GREATER LONDON AUTHORITY

Our Ref: MGLA290121-4937

Site name: Homebase Manor Road

Local planning authority reference: 19/0510/FUL

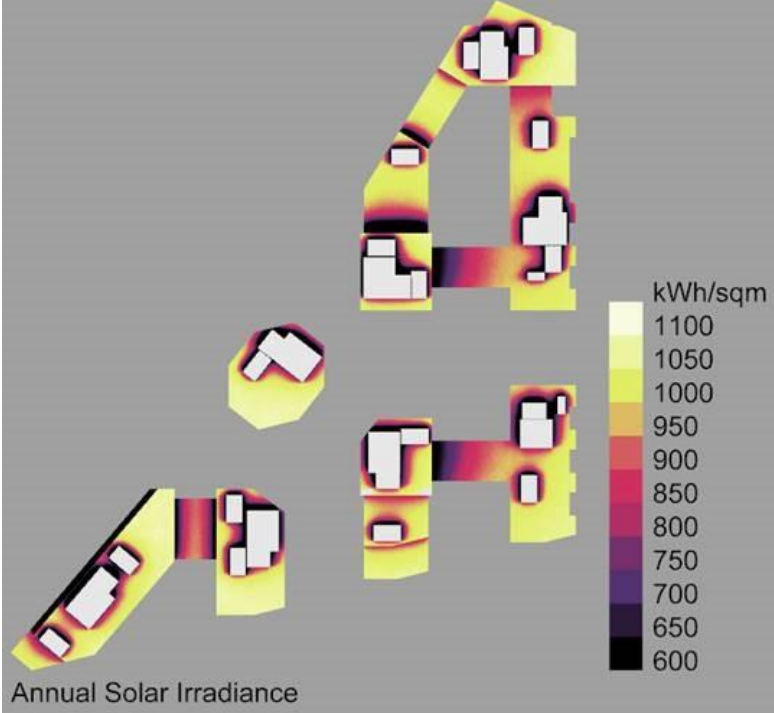
29. PV is being proposed equating to circa 120 m² of net PV area; the applicant should confirm the proposed kWp. From the basic roof layout provided, there appears to be additional space for PV. A detailed roof layout should be provided demonstrating that the roof's potential for a PV installation has been maximised and clearly demonstrating any constraints. The applicant is required to maximise the on-site savings from renewable energy technologies, regardless of the London Plan targets having been met, and therefore the PV proposals should be reviewed. It should also be noted that the PV savings reported of 3.3 tonnes of CO₂ /annum are considered very low.

The applicant has identified one further location suitable for a PV array which could accommodate 13 further panels, equivalent to approx. 20 m² of PV panel area, and equivalent to an additional 4kWp (i.e. now a total of 22kWp). They suggest this is estimated to result in 0.6 tCO₂ additional carbon emission reductions (i.e. now a total estimated carbon emission reduction of 3.9 tCO₂/year from PV). They have provided an updated roof layout which are labelled to show areas where roofs are expected to be overshadowed, and where they consider roof areas to be of insufficient size to accommodate an array of PVs. However, the roof areas labelled to be of insufficient size to

accommodate an array of PV appear to be sufficiently large in our experience, and it is unclear what level of overshadowing is expected to areas labelled as such. The applicant should provide further detail and provide solar insolation levels.

28c	The applicant has provided a datasheet confirming their assumptions, including the run-time and external temperature as per item b. (...) They should confirm the proposed size of the heat pumps.	Approximately 2.8MW of ASHP heating is provided across the site in module sizes varying from 90-250kW.			
28e	A commitment to monitor the performance of the heat pump system post-construction to ensure it is achieving the expected performance approved during planning.	The client has confirmed they will commit to monitoring the performance of the heat pump system post-construction and compare against the expected performance estimated during planning. Suitable commissioning will be carried out of the system to ensure optimised performance.			
29	Solar PV and roof space availability: the applicant should provide further detail and provide solar insolation levels.	A solar irradiance study of the roofs has been completed – see image below. Due to some updates in the allocation of plant space, it would be prudent to move two of the arrays, however the over-all estimated allocation is unchanged (140m ² of PV panel area). See updated mark-up attached. Grey areas in the attached are allocated for

Item #	Query	Team response
		<p>mechanical plant space or overshadowed areas, red areas are areas that are deemed too small for a PV array (less than 15 panels would fit).</p> <p>Further PV allocation is not deemed suitable for the following reasons:</p> <ul style="list-style-type: none"> - All remaining unshaded locations would only allow for small arrays (<15 panels each). - Such small arrays would have a negligible impact on the carbon emission reductions for the development - Small PV arrays are less efficient due to inverter losses (each array would need a separate inverter) - The development is already expected to achieve in excess of 35% carbon emission reductions based on the current design. 
32	The applicant has confirmed that they have currently omitted the CO ₂ emissions reduction associated with PV. Once all other comments are resolved, they should provide updated CO ₂ emissions reductions for all stages of the energy hierarchy, including the CO ₂ emissions from PV.	To clarify: We have not omitted the carbon emission reductions from our calculations, however they are not included in the SAP calculations for the apartments at the current point in time, but were added to the calculations separately. Updated CO ₂ emission reductions at each stage of the energy hierarchy are set out in the Appendix E. This includes the additional PV array identified by the team in the previous response (i.e. total array now 140 m ² PV panel area).

Site Name:	84 Manor Road TW9 1YB
Planning reference number:	2018/5833
Consultant:	
Comments provided on:	17/06/19

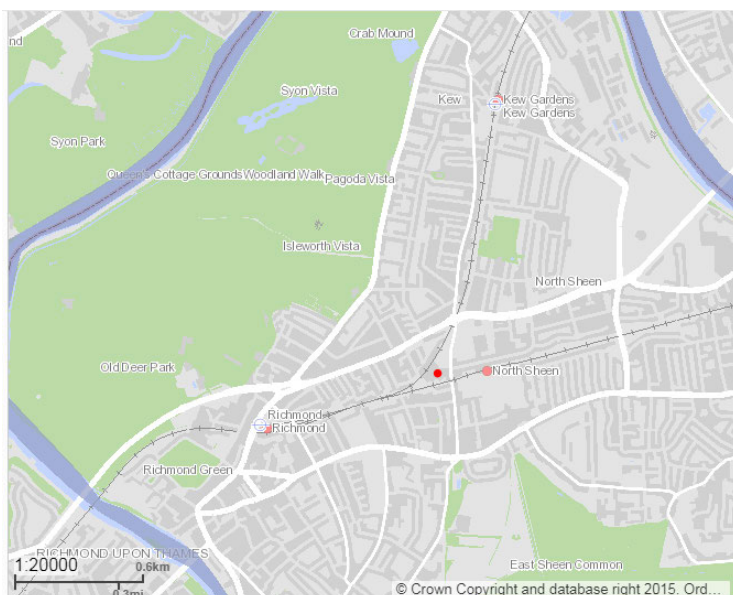
21. The applicant has carried out an investigation and there are no existing or planned district heating networks within the vicinity of the proposed development. They should contact the borough and ask whether they know of any schemes coming through; evidence of this correspondence should be provided.

The applicant has confirmed they have contacted the Borough of Richmond Upon Thames, but are yet to receive a response. They should submit the response when it is received.

For the proposed development at the applicant has carried out an investigation and found that there are no existing or planned district heat networks within the vicinity of the proposed development. They have been asked to contact the borough to see if they were aware of any upcoming schemes, the council have then forwarded this search to Climate Integrated Solutions (CIS).

After review of the available evidence CIS has concluded that there are no upcoming schemes in the vicinity of the proposed development.

However the nature of the surrounding plots makes it reasonably likely that currently unforeseen DHN's will be developed in the area within the building lifetime, therefore in line with *the Greater London Authority guidance on preparing energy assessments* basic futureproofing should be provided, including providing space in plantrooms for heat exchangers and leaving a likely path for connecting pipes as clear as possible.

EAHV-P900Y(A)(H)

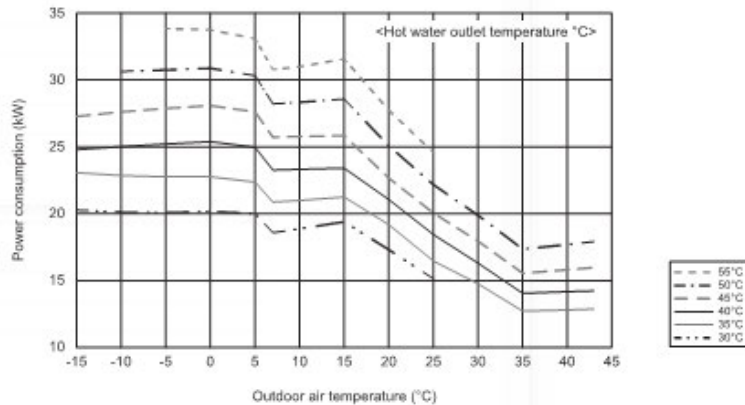
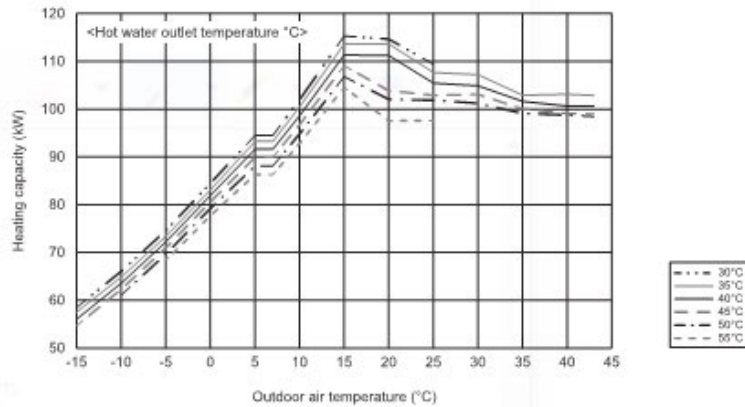
d. The expected heat source temperature and the heat distribution system temperature with an explanation of how the difference will be minimised to ensure the system runs efficiently.

The applicant has confirmed that the design heat source (air) temperature is -4°C, and the proposed LTHW distribution temperature is 55°C. This has been chosen to minimise the amount of DHW production which will be borne by the direct electric element. They have suggested that reducing the LTHW distribution temperature would increase the proportion of direct electric heating required, which would significantly increase the running cost to all residential occupants, and the total carbon emissions of the system. Therefore, they confirm that although a lower distribution temperature could provide benefits in terms of ASHP efficiency and distribution loss reductions, it has been considered that the proposed solution will result in the best overall outcome for the scheme. Nothing further required.
